To editor:

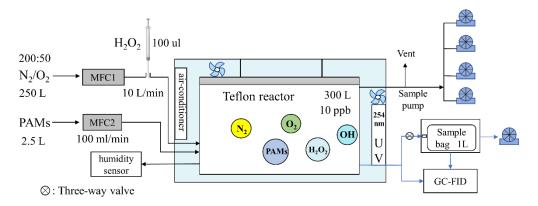
3. Figure 1 Schematic: I think you mean 'humidity sensor'. Also "Controller" is missing the 'r' on the end.

Reply: Thanks for your valuable suggestions! Modifications have been made in the revised manuscript.
